# Wayzata Planning Commission

## Meeting Agenda

Monday, November 21, 2016

Date: November 18, 2016  
To: Planning Commission  
From: Jeff Thomson, Director of Planning and Building  
Subject: Meyer Place on Ferndale

**1** Second Floor Setback Exhibit  
scale:

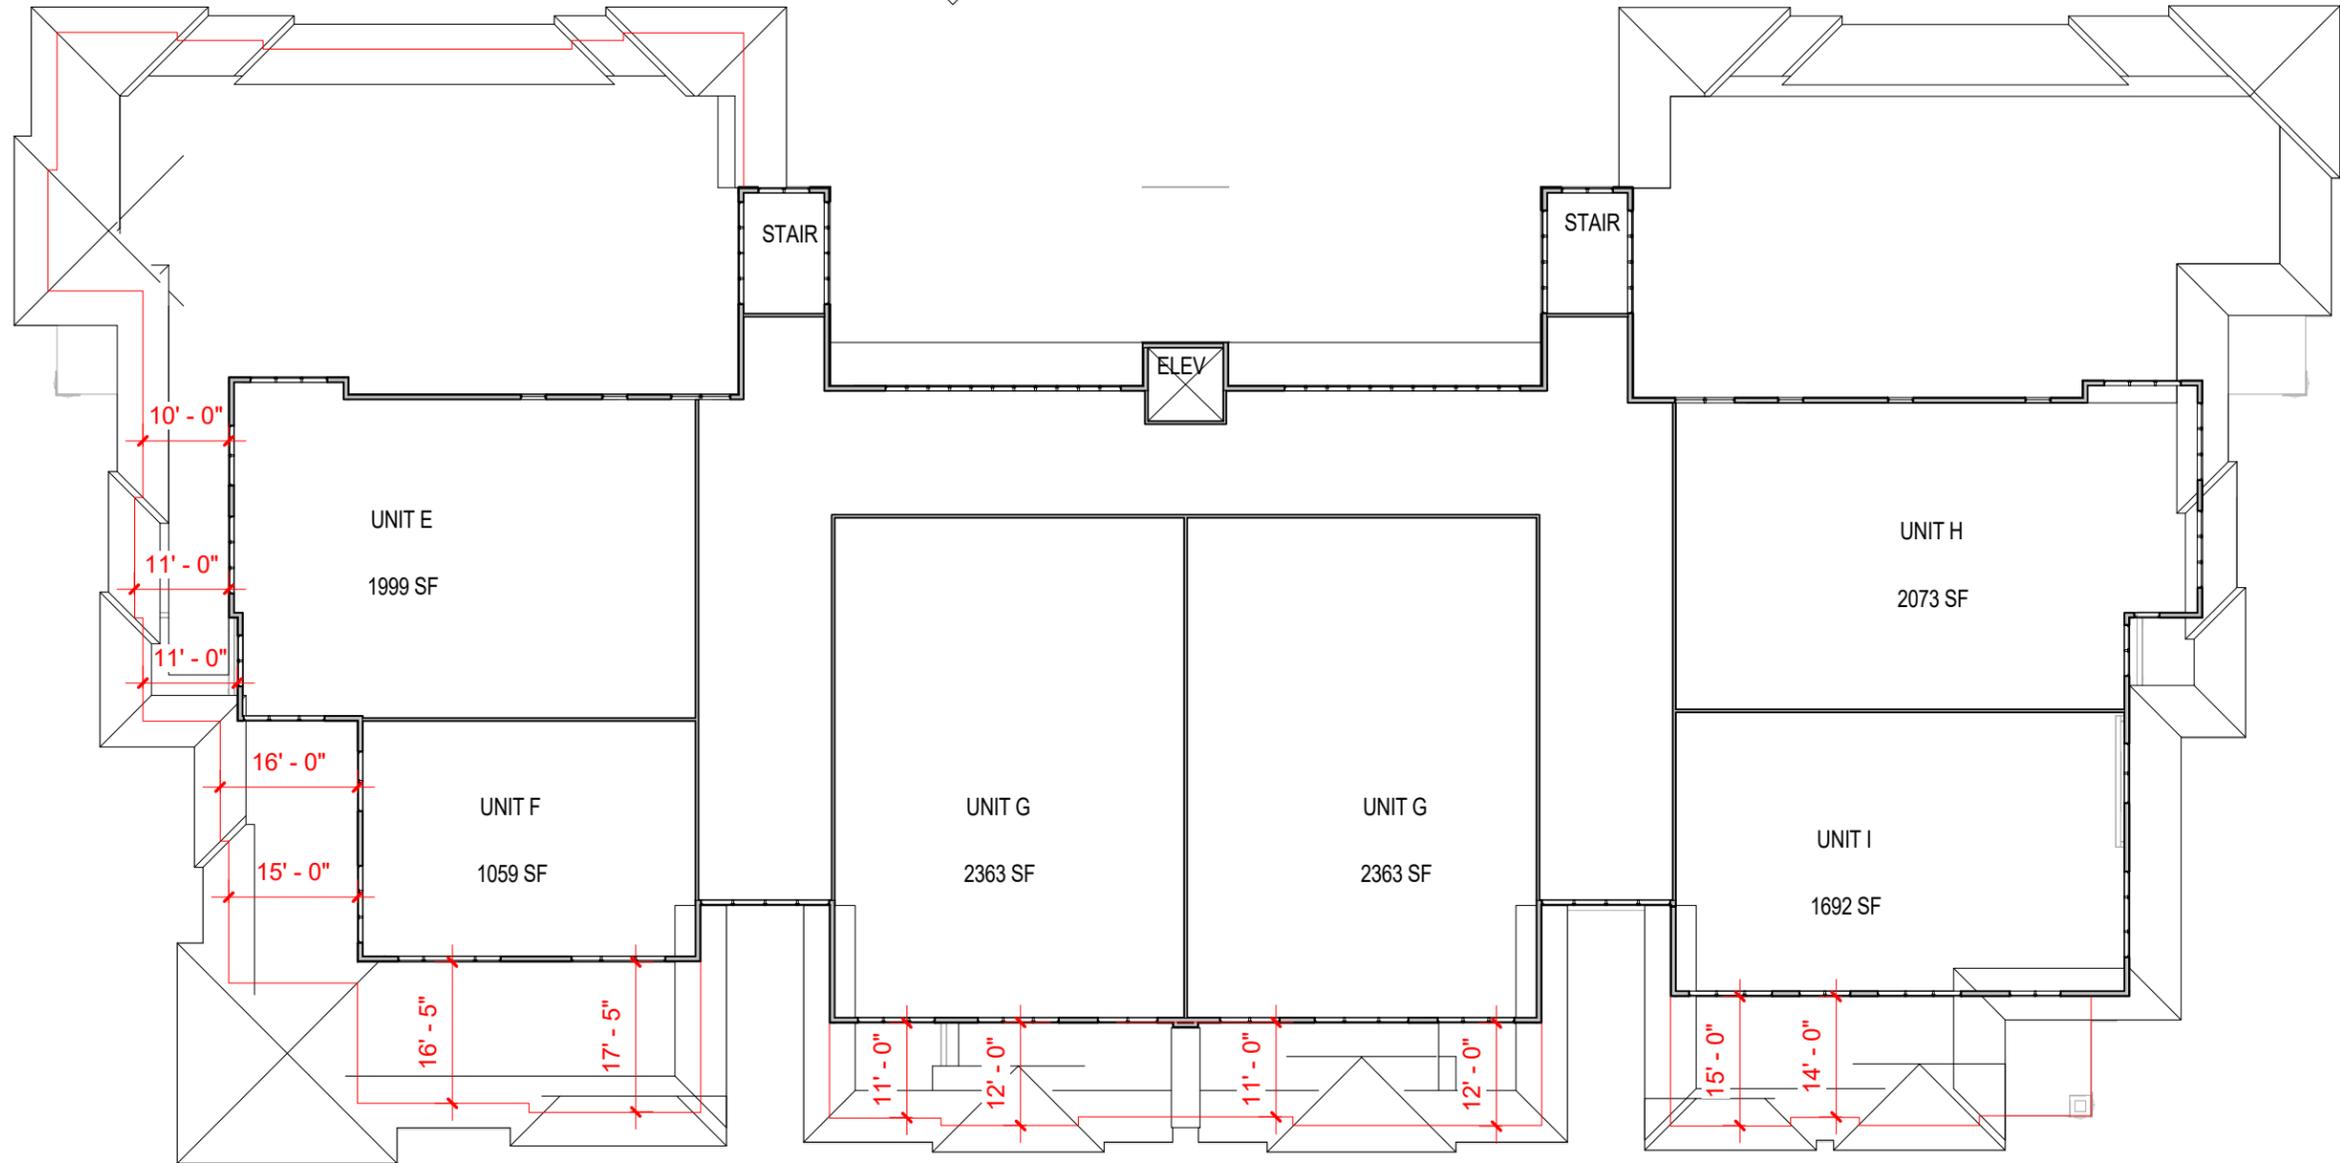
- The applicant has provided additional information regarding the second floor along Lake Street. The second story along Lake Street would be stepped back for 23% of the building length. The second story is stepped back 12 to 15 feet from the first floor in the balcony locations. The applicant has also indicated that both the first and second floors are stepped back from the property line along Lake Street, which breaks up the mass of the building and meets the intent of the design standard.
- Additional windows have been added to the rear elevation of the building that faces the residential properties to the north.
